# UNITED STATES PATENT AND TRADEMARK OFFICE

APPLICATION NO.	FILING DATE	FIRST NAMED INVENTOR	ATTORNEY DOCKET NO.	CONFIRMATION NO.
10/709,722	05/25/2004	Anthony K. Stamper	BUR920030189US1	3721

**Office Action Summary**

## **DETAILED ACTION**

FIG. 2D

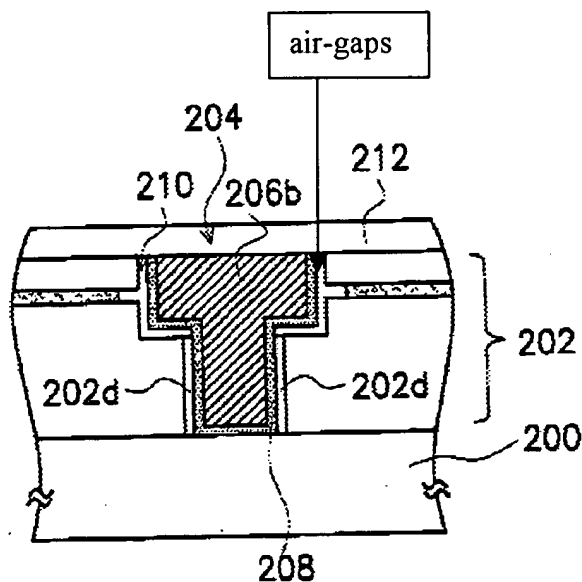
Regarding claim 16, Lee discloses in e.g., Fig. 2B - Fig. 2D a semiconductor device, comprising:

- a metal wiring level (202; section 0022, line 3) having alternating layers of a first dielectric material (202c; section 0022, lines 6 – 7) and a second dielectric material (202b; section 0022, lines 9 – 12) and having a first feature (204; section 0022, lines 20 – 21) formed within the alternating layers of first and second dielectric material (see e.g., Fig. 2D); and
- a plurality of openings (air-gaps; section 0025 and see Fig. 2D on this page of Office action) within the first dielectric material.

Regarding claim 17, Lee discloses in e.g., Fig. 2D the first dielectric material comprising a material that etches selectively to the second dielectric material (section 0022, lines 9 – 11).

Regarding claim 21, Lee discloses in e.g., Fig. 2D a conductive material (206b; section 0025, lines 9 – 10) within the first feature (204).

Regarding claim 19, Lee discloses in e.g., Fig. 2D the openings (air-gaps) being within a wire trench portion (at the location of the element 210) of the dual damascene feature and not a via trench portion (at the location of the element 208; see Fig. 2D).

Regarding claims 20 and 29, while Lee teaches a conformal liner (212) over a surface of the alternating layers of dielectric material (202) to seal the alternating layers (see e.g., Fig. 2D), Lee does not appear to provide any example of the conformal liner's specific composition. Pang teaches in e.g., Fig. 15 a conformal liner (138) being composed of SiN (column 9, lines 42 – 43). It would have been obvious to one of ordinary skill in the art at the time when the invention was made to apply the SiN of Pang as the specific material to form the conformal liner of Lee as taught by Pang to provide a chemically sufficiently different material from the previous dielectric layer to be effective as an etch stop (column 9, lines 43 – 45).
